Rev: - Comments: - By: - Date: -				LISTED BUILDING CONSENT Client: Mr. Simon Dougall Project Title: 107 High St, Lindfield, Haywards Heath, West Sussex, RH16 2HR Drawing Title: Detail Drawings: Balustrade to terrace - Sheet 1 of 2 Scale: 1:25@A1 1:10@A1 1:50@A3				kyson Studio 28 Scrutton Street London UK EC2A 4RP T: +44(0) 20 7247 2462 E: enquiries@kyson.co.uk W: www.kyson.co.uk Project No.: 900-25			
Do not scale this drawing. All dimensions must be checked on site. All rights reserved. No reproduction in any material form is permitted without consent.				Date: Apr 25				Drawing No.: 5024			
				Drawn: KN				Checked: KW			
								Revision: -

As Built / Proposed West Elevation
Scale 1:25@A1
1:50@A3

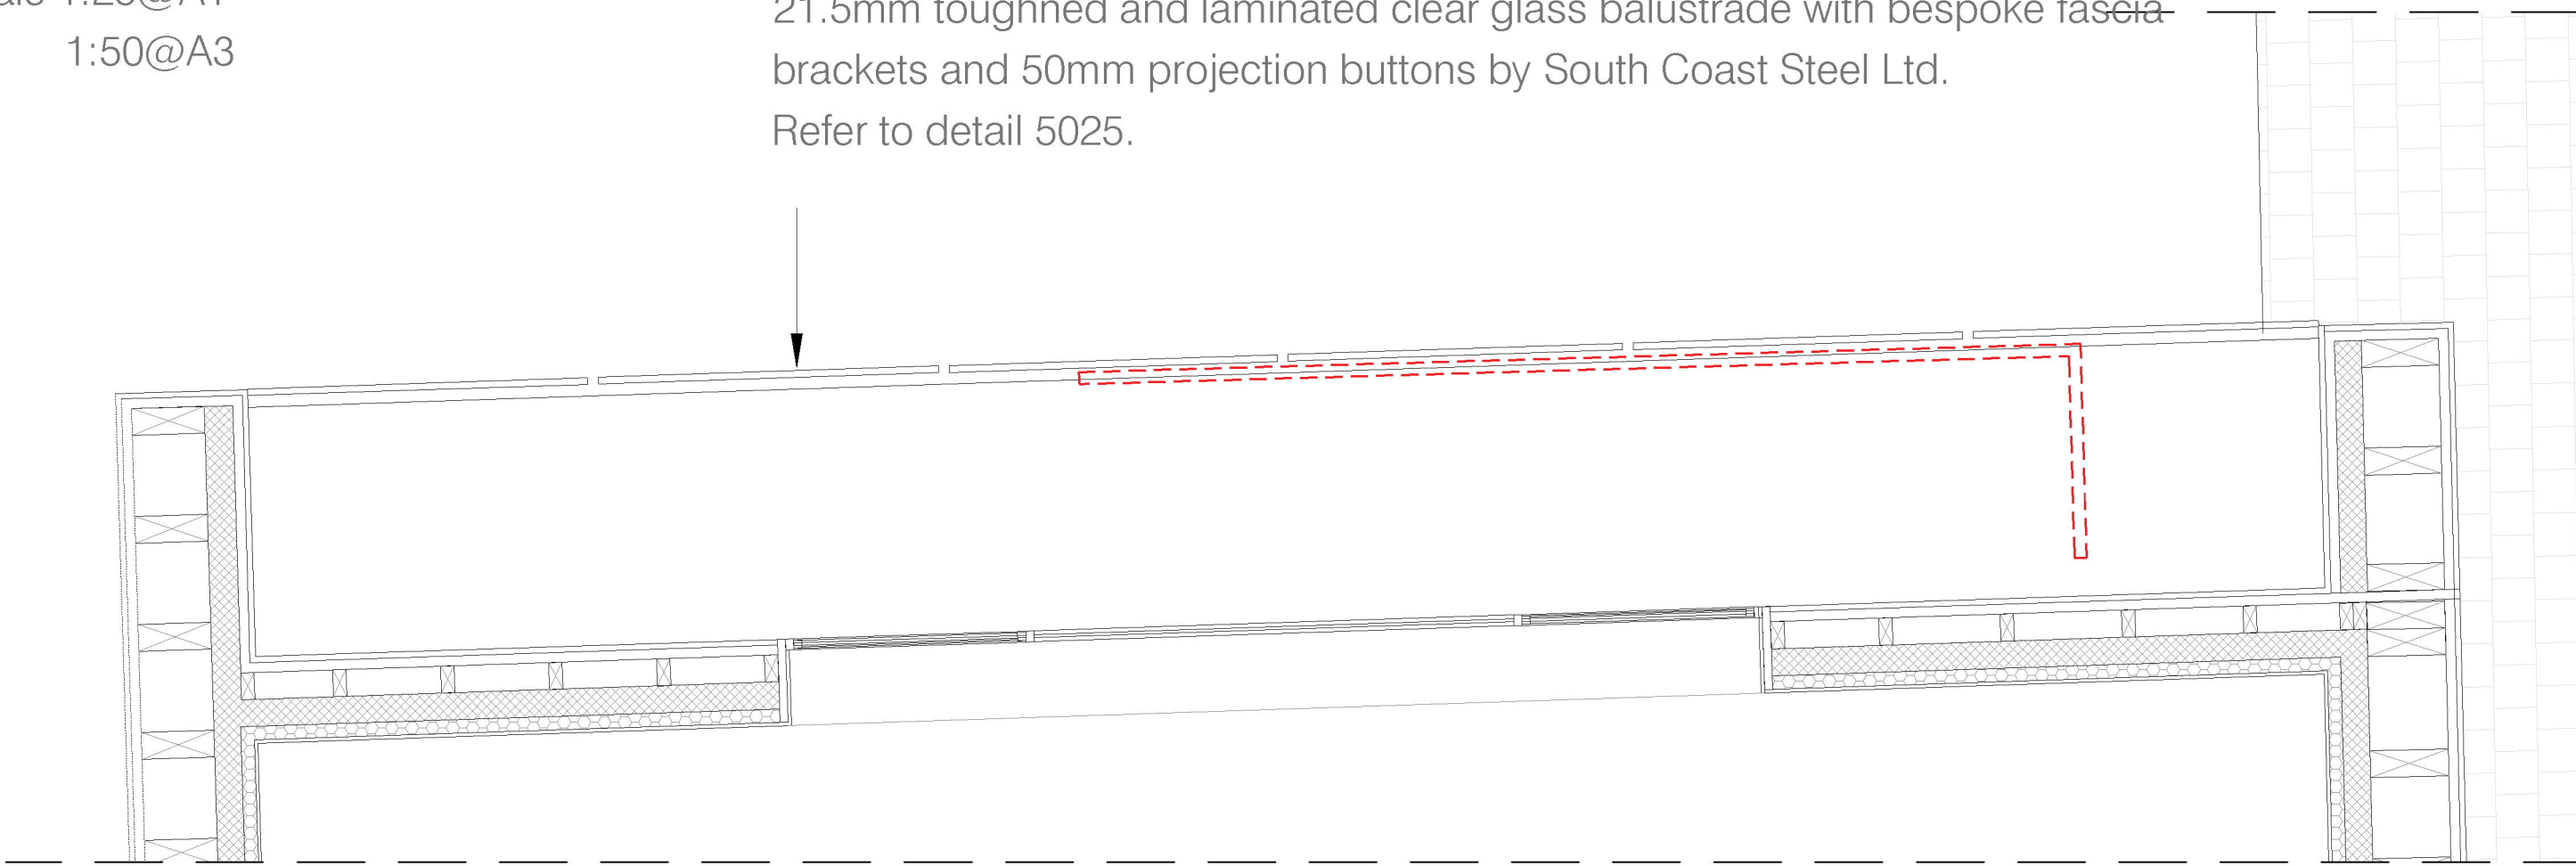
21.5mm toughened and laminated clear glass balustrade with bespoke fascia brackets and 50mm projection buttons by South Coast Steel Ltd. Refer to detail 5025.
